Contract #: 04-0120F4Cty: SF/ALA Rte: 80 PM: 13.2/13.9File #: 69.25B**QUALITY ASSURANCE -- NON-CONFORMANCE REPORT****Location:** Changxing Island, Shanghai, P.R. China**Report No:** NCR-000570**Prime Contractor:** American Bridge/Fluor Enterprises, a JV**Date:** 29-Dec-2009**Submitting Contractor:** Zhenhua Port Machinery Company, Ltd (ZPMC), Changxing Island**NCR #:** ZPMC-0543**Type of problem:**

Reference Description: Missed UT indications by QC on Segment 8CW Side to Edge Plate Joint**Description of Non-Conformance:**

To:	AMERICAN BRIDGE/FLUOR, A JV 375 BURMA ROAD OAKLAND CA 95607	Date:	30-Dec-2009
Dear:	Mr. Charles Kanapicki	Contract No:	04-0120F4 04-SF-80-13.2 / 13.9
Attention:	Mr. Thomas Nilsson Project/Fabrication Manager	Job Name:	SAS Superstructure
Subject:	NCR No. ZPMC-0543	Document No:	05.03.06-000533

Job Name: SAS Superstructure

WELD NUMBER: SSD13A-PP065-128

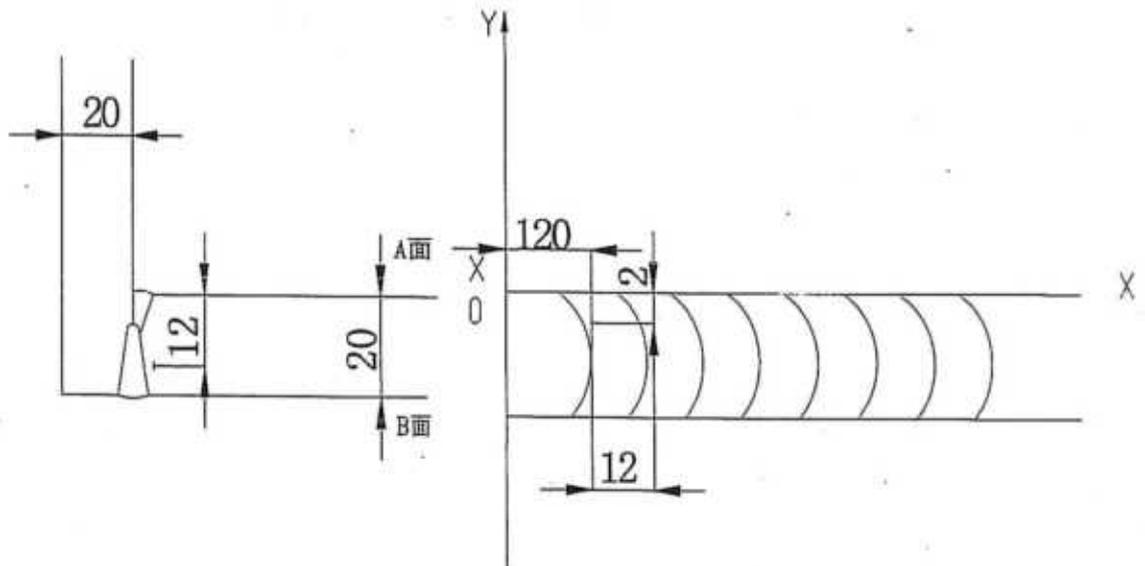
Rejected indication found by ultrasonic inspection is less than the maximum allowance aggregate length.

1. Did not clear the weld pass completely in time.

1. Gouge or grind from nearer side from metal edge ($D \leq 0.65T$, "D" is depth of defects, "T" is thickness of metal) to remove all defects;

2. Follow repair WPS for joint preparation, preheat, and weld deposit;

3. Verify with VT no defects remain in the weld joint prior to welding;

4. Grind the repaired area flush with base metal or the adjacent weld;

5. Perform UT inspection to the weld along with 50mm on each end of the repair area;

WELD NUMBER: SEG048*-005

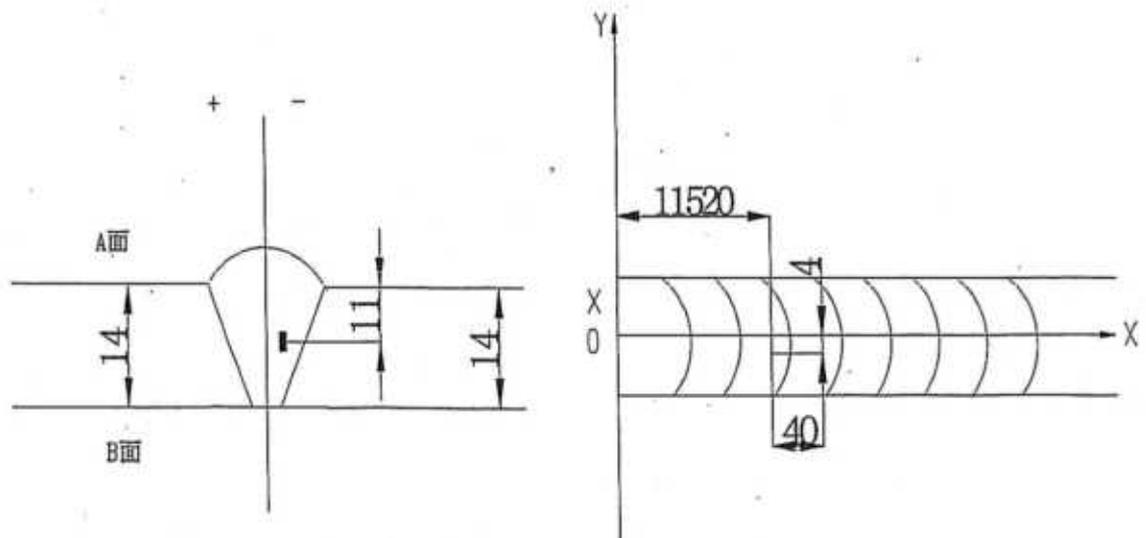
Rejected indication found by ultrasonic inspection is less than the maximum allowance aggregate length.

1. Did not clear the weld pass completely in time.

1. Gouge or grind from nearer side from metal edge ($D \leq 0.65T$, "D" is depth of defects, "T" is thickness of metal) to remove all defects;

2. Follow repair WPS for joint preparation, preheat, and weld deposit;

3. Verify with VT no defects remain in the weld joint prior to welding;

4. Grind the repaired area flush with base metal or the adjacent weld;

5. Perform UT inspection to the weld along with 50mm on each end of the repair area;

(UT探伤发现的缺陷总长度小于最大允许长度。) CA053-003

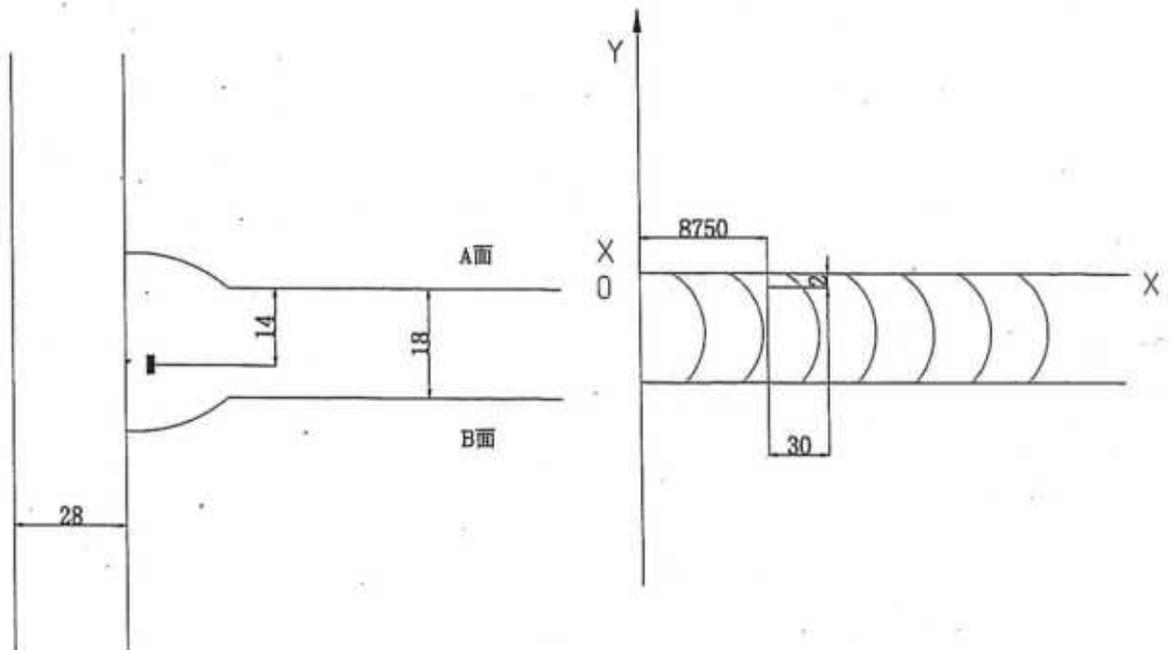
Rejected indication found by ultrasonic inspection is less than the maximum allowance aggregate length.

1. 从缺陷距高端面较近一侧 ($D \leq 0.65T$, D为缺陷深度, T为板厚) 采用碳刨或打磨的方法去除焊缝缺陷;
 2. 参照返修焊接工艺规程 (WPS) 准备正确的接头型式, 预热和焊接;
 3. 焊前对修补区域进行VT检测保证缺陷完全被消除;
 4. 将修补区域打磨到与母材或邻近焊缝平齐;
 5. 对焊缝进行UT检测, 检测范围为返修区域以及其两端各延长50mm.
-
1. Gouge or grind from nearer side from metal edge ($D \leq 0.65T$, "D" is depth of defects, "T" is thickness of metal) to remove all defects;
 2. Follow repair WPS for joint preparation, preheat, and weld deposit;
 3. Verify with VT no defects remain in the weld joint prior to welding;
 4. Grind the repaired area flush with base metal or the adjacent weld;
 5. Perform UT inspection to the weld along with 50mm on each end of the repair area;

(UT探伤发现的缺陷总长度小于最大允许长度。) SEG047B-012

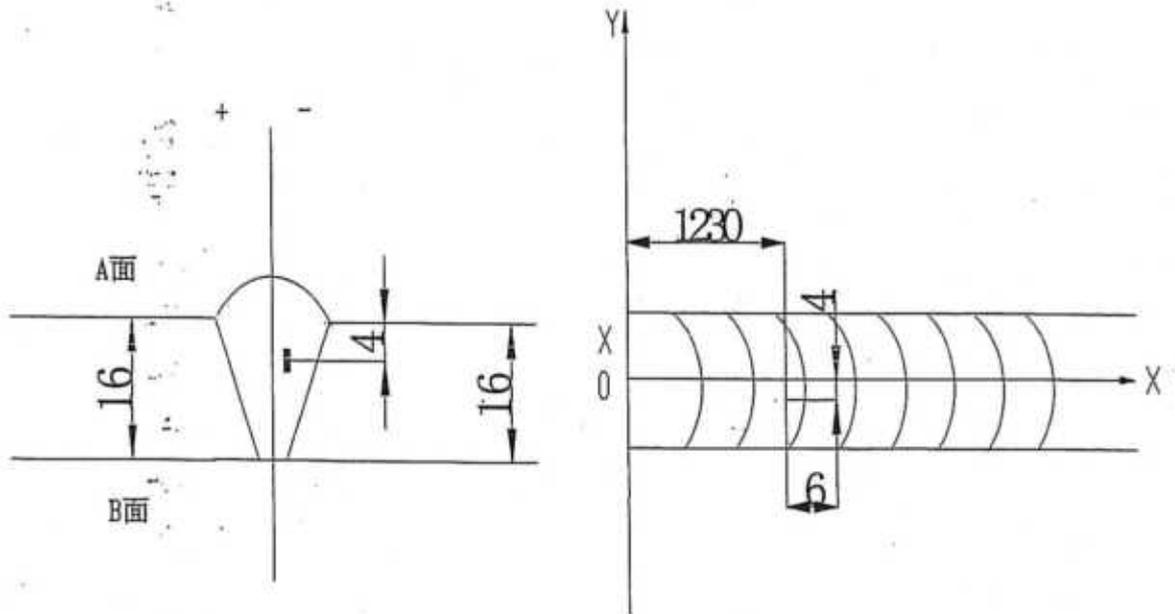
Rejected indication found by ultrasonic inspection is less than the maximum allowance aggregate length.

1. Gouge or grind from nearer side from metal edge ($D \leq 0.65T$, "D" is depth of defects, "T" is thickness of metal) to remove all defects;

3. Verify with VT no defects remain in the weld joint prior to welding;

(UT探伤发现的缺陷总长度小于最大允许长度。) SEG047B-013

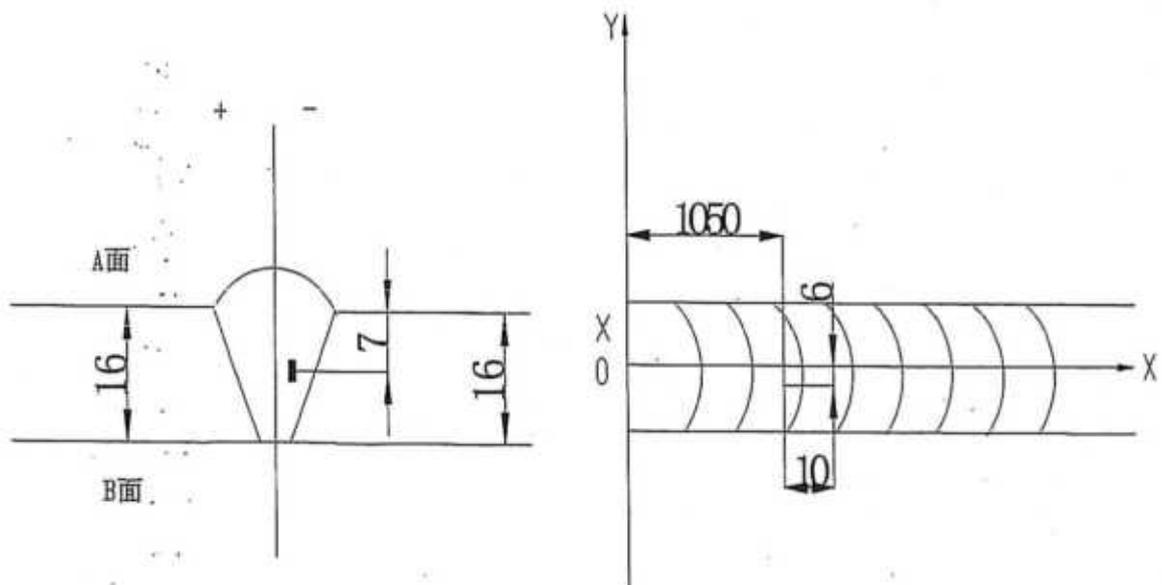
Rejected indication found by ultrasonic inspection is less than the maximum allowance aggregate length.

1. Gouge or grind from nearer side from metal edge ($D \leq 0.65T$, "D" is depth of defects, "T" is thickness of metal) to remove all defects;

3. Verify with VT no defects remain in the weld joint prior to welding;
